**MONTGOMERY COUNTY PLANNING DEPARTMENT**  
THE MARYLAND-NATIONAL CAPITAL PARK AND PLANNING COMMISSION

**TO:** Montgomery County Board of Appeals  
**VIA:** Robert Kronenberg, Acting Chief, Development Review Division *RAK*  
Ralph Wilson, Zoning Supervisor, Development Review Division *RW*  
**FROM:** Elsabett Tesfaye, Planner Coordinator (301) 495-1301 *ET*  
**SUBJECT:** Special Exception S-2351-A Mid-Atlantic Petroleum Properties, LLC-Request for modification to approved special exception for a Gas Station in the I-1 Zone

# S-2351-A

**SUBJECT: S-2351-A Mid-Atlantic Petroleum, Special Exception Modification**

LANDSCAPE PLAN  
AMENDMENT TO SPECIAL EXCEPTION (S-2351) MODIFICATION  
**GERMANTOWN INDUSTRIAL CENTER**  
PARCEL "E", N940, PLAT 19869  
9TH ELECTION DISTRICT - MONTGOMERY COUNTY - MARYLAND

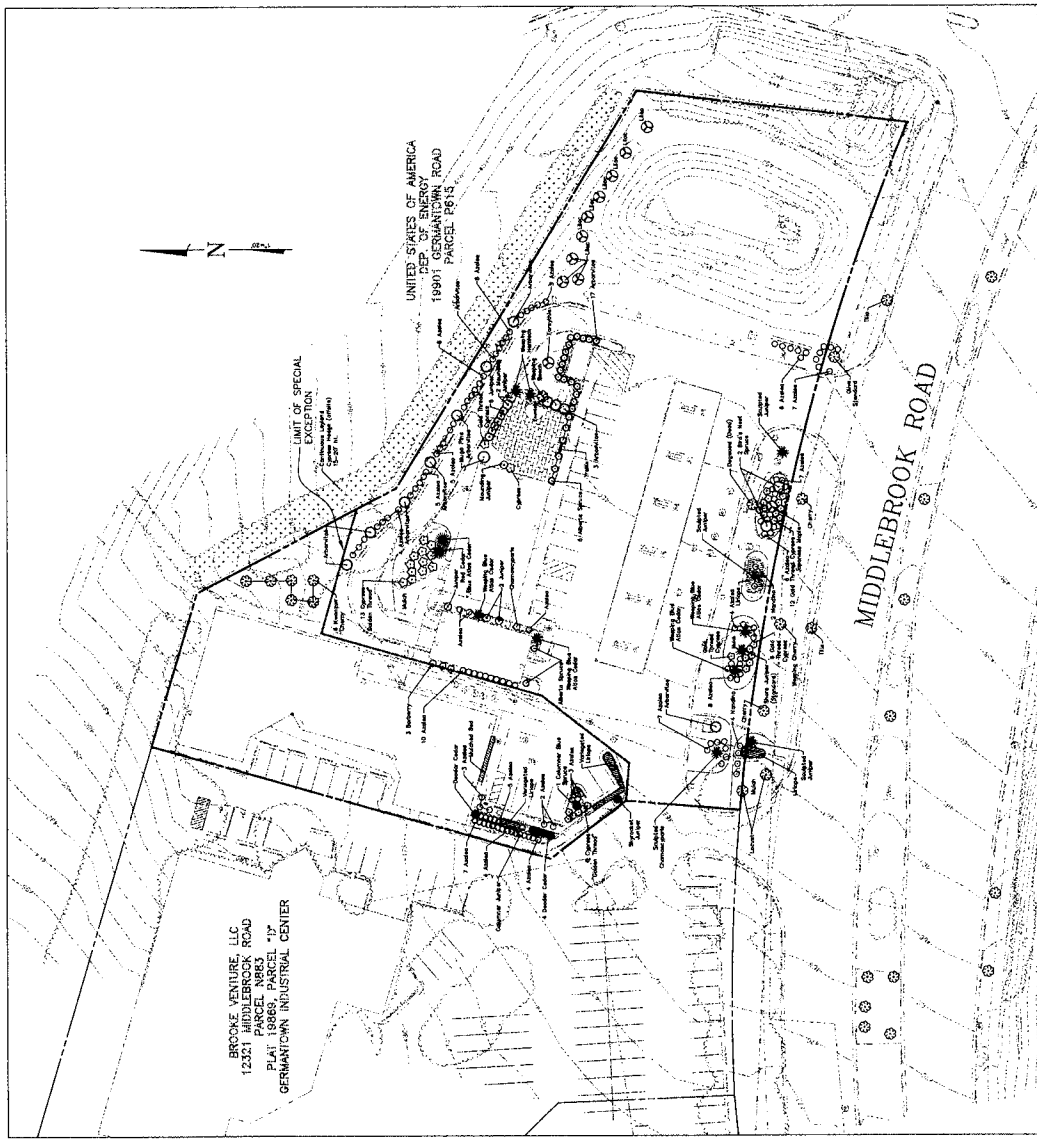
Upon reviewing the revised landscape plan the Design Division staff (See attached Memorandum from Karen Kumm, dated June 24, 2009) has indicated that the proposed modification does not satisfy the zoning requirement because it relies on low ground covers instead of providing a 3 foot evergreen hedge. The proposed hedge is lower than the required 3 foot hedge and will not screen, now or in the future, the views from the road. The 3 proposed along Middlebrook Drive will help reduce the visual impact of the gas station, but do not meet the minimum requirements for a tree every 40 feet. Staff recommends 2 additional trees along with the 3 foot hedge to satisfy the planting requirements

The Design Division staff has further indicated that the 1994 approved Germantown streetscape plan that calls for a single row of deciduous shade trees, 2 ½ “ in caliper to be planted 45’ on center along the curb. The proposed plans show only two existing street trees along the curbside. There are additional ornamental cherries planted behind the existing bike-path. The Design Division staff recommends that the Applicant should plant a minimum of 2 additional street trees. The trees should match the existing planted species, *tilia cordata* “greenspire”.

Staff generally agrees with the conditions recommended by the Design Division However, the elimination of the existing plant that existed on the property for several years does not appear to be practical and recommends supplemental plant material to be installed without necessitating the removal of the existing vegetation. However, if the Applicant wishes to remove the existing plant materials, staff has no objections.

driveway to the carwash and the rear portion of the property. Staff recommends additional planting along the properties frontage on Middlebrook Road to meet the landscape requirements of § 59-E-2.71 and the 1994 Germantown Streetscape Concept Plan. Staff also recommends that the gate to the dumpster enclosure be repaired and painted with green paint so it would blend with the landscaping around it.

3. The landscape plan must be revised to incorporate the following improvements to the landscape strip adjacent to the public right-of-way for review and comment by Planning Board staff and transmitted for approval by the Board of Appeals:

- a. Install 2 new little Leaf Lindens, 2<sup>1/2</sup>– 3” caliper to match the existing tree species within the public right-of-way, where horizontal spaces permit, approximately 45 feet on center to either side of the existing bike path.

- b. Supplement the existing Juniper hedge with 2-foot-high, evergreen shrubs—install at 3’ or they should be able to grow to 3’.
  - c. Provide 2 additional 2<sup>1/2</sup>– 3” caliper Zelkova shade trees, increasing the proposed 3 Zelkovas to 5 Zelkovas.
